STANDARD TRENCH DETAIL
NTS

WATER CONTRACT NO. WD-2775
CONTRACT NO. 2652J

CITY AND COUNTY OF SAN FRANCISCO PUBLIC UTILITIES COMMISSION INFRASTRUCTURE DIVISION ENGINEERING MANAGEMENT BUREAU			
INSTALLATION OF 16-INCH AND 36-INCH, AND RELOCATION OF 8-INCH DUCTILE IRON WATER MAINS AT VARIOUS LOCATIONS ON 19TH AVENUE FROM HOLLOWAY AVENUE TO LINCOLN WAY			
WATER TRENCH DETAIL FOR CALTRANS RIGHT OF WAY			
CHECKED / APPROVED	BY / EC	DRAWN	AS SHOWN
SECTION MANAGER	T. LEE	DESIGNED	OCT 2018
APPROVED	<i>[Signature]</i>		APPROVED
MANAGER, ENGINEERING MANAGEMENT BUREAU	PLAN NO.		MANAGER, CITY DISTRIBUTION DIVISION
SHEET	WD-2775-13	DRAWING NO.	REVISION NO.
. OF .	E-31382

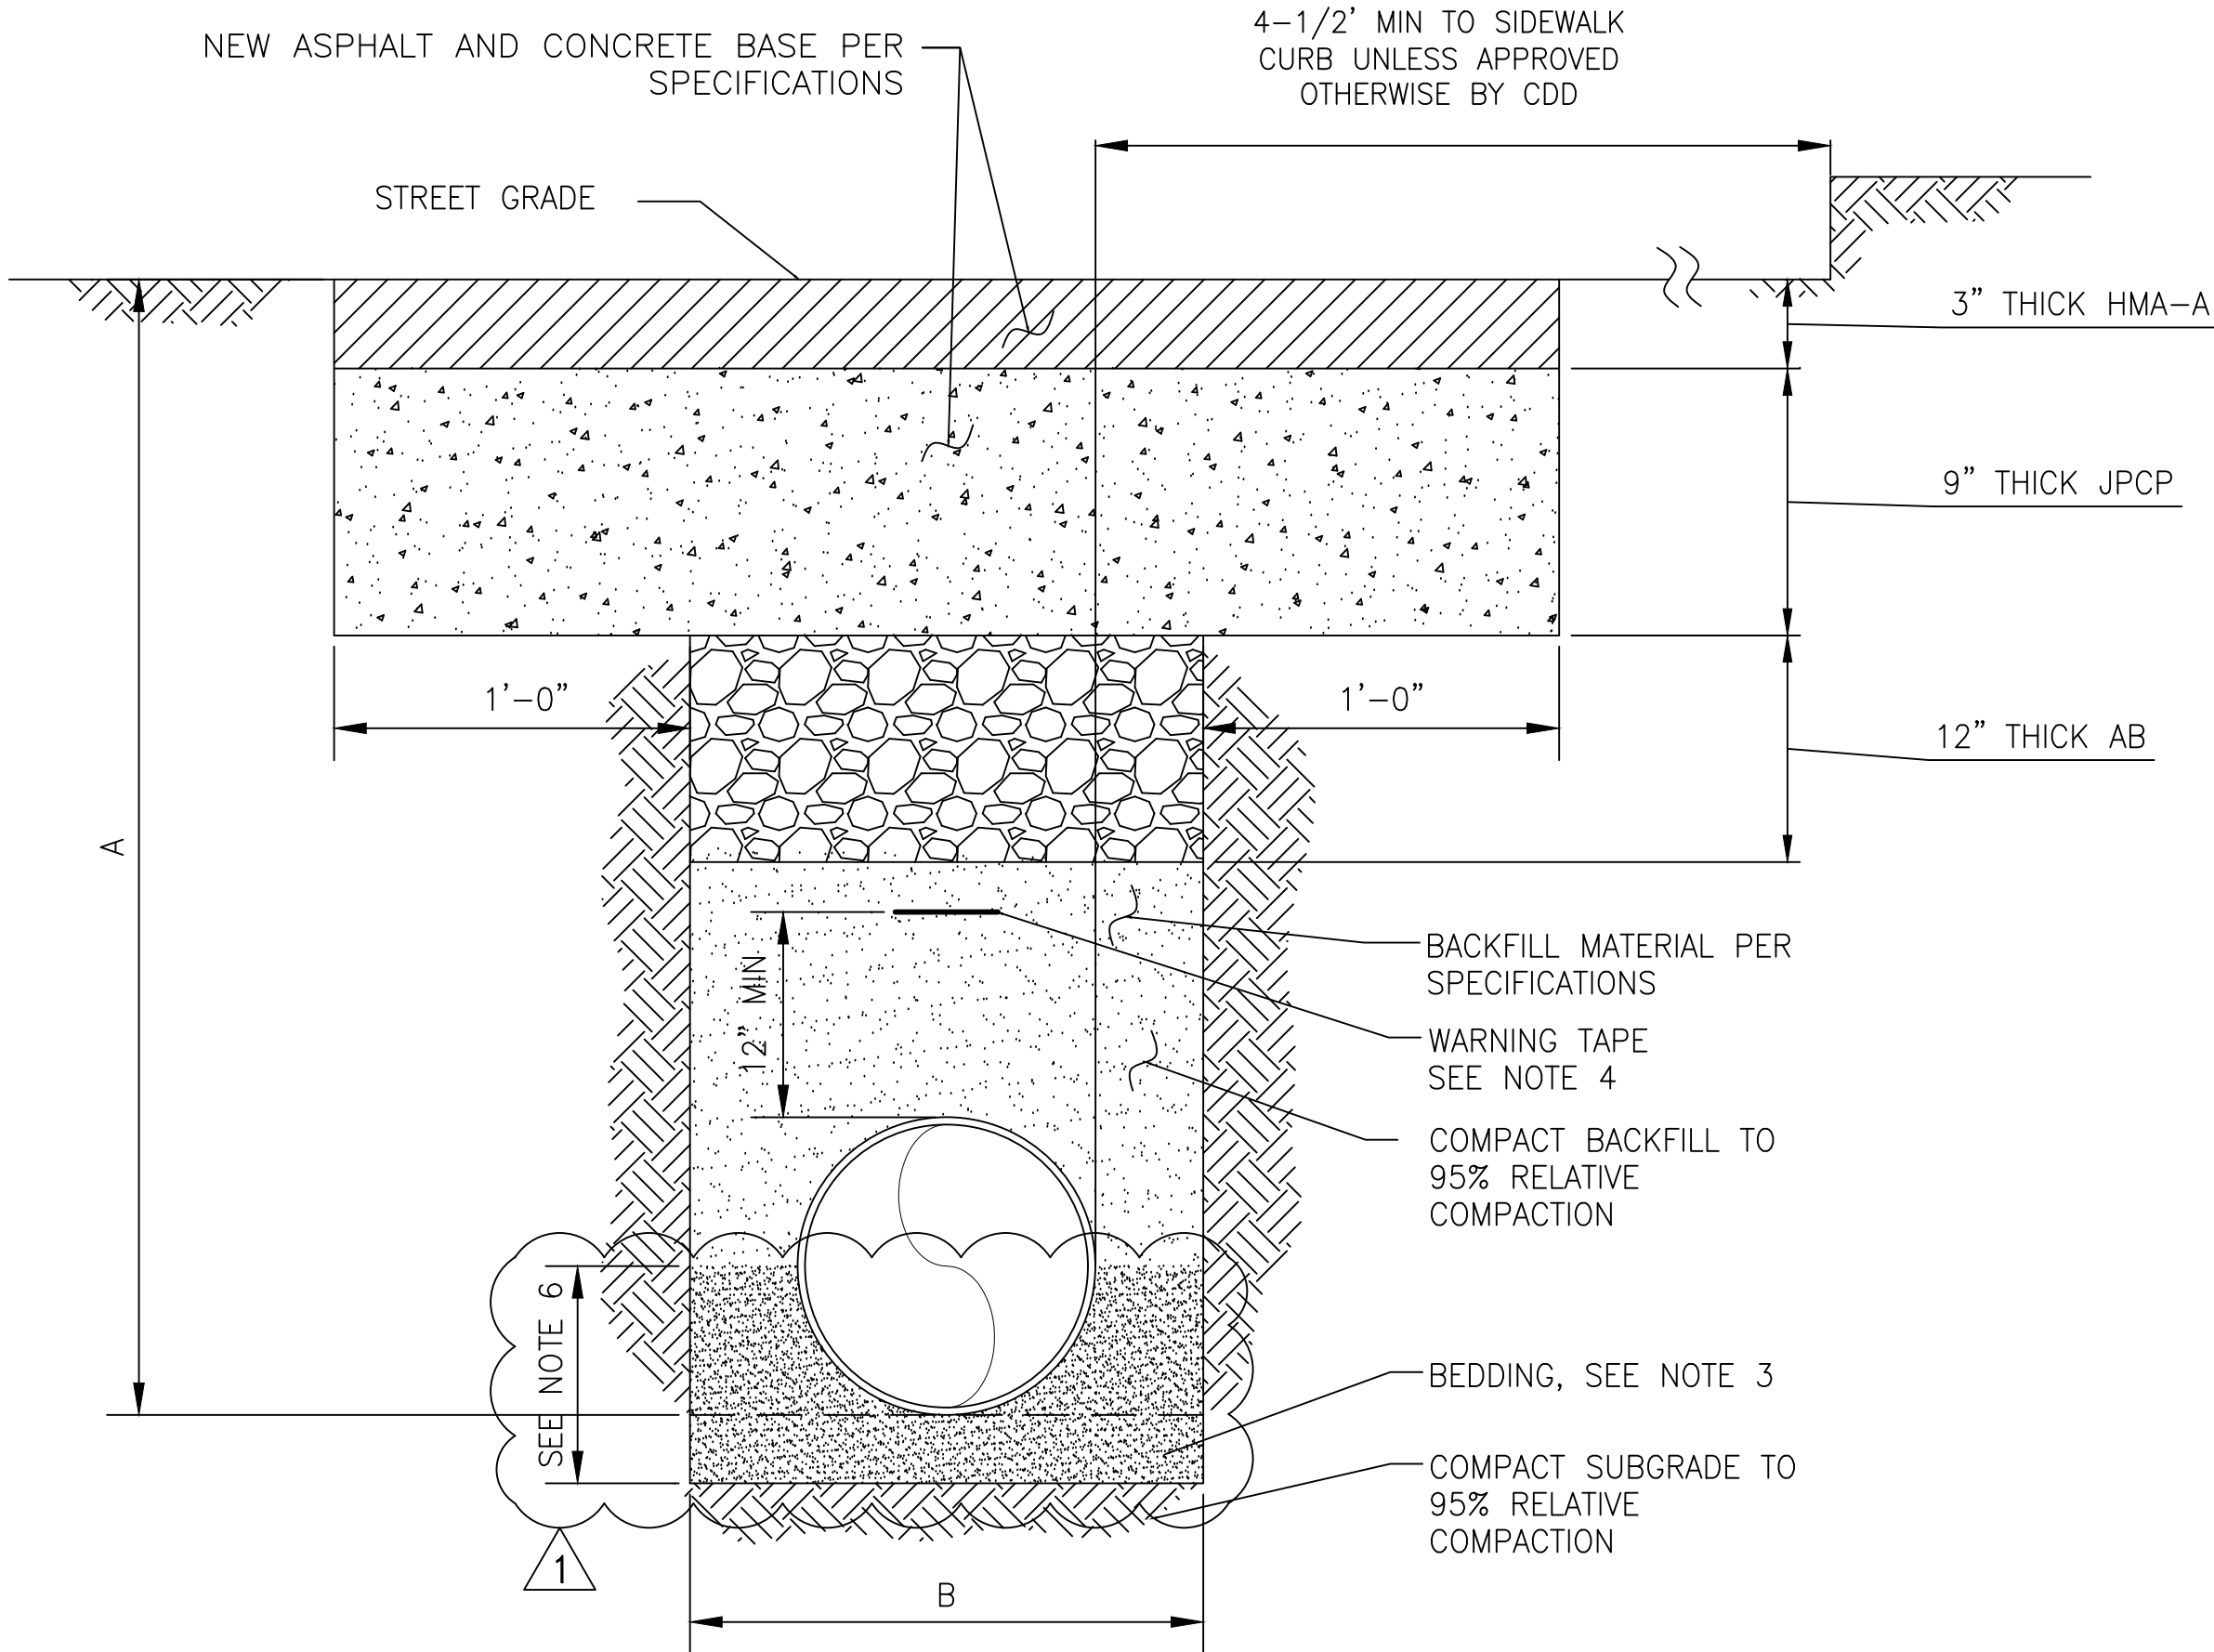
NO.	DATE	DESCRIPTION	BY	APPR'D
1	03/10/21	PCO #3 - REVISE NOTE 6	IC	JA
REVISIONS

6. ONLY FOR 36" DIA PIPE, BACKFILL SHALL BE CONTROLLED LOW STRENGTH MATERIAL (CLSM) FROM BOTTOM OF TRENCH TO SPRINGLINE OF PIPE. CLSM SHALL HAVE A MAX 100 PSI COMPRESSIVE STRENGTH AT 28-DAYS.
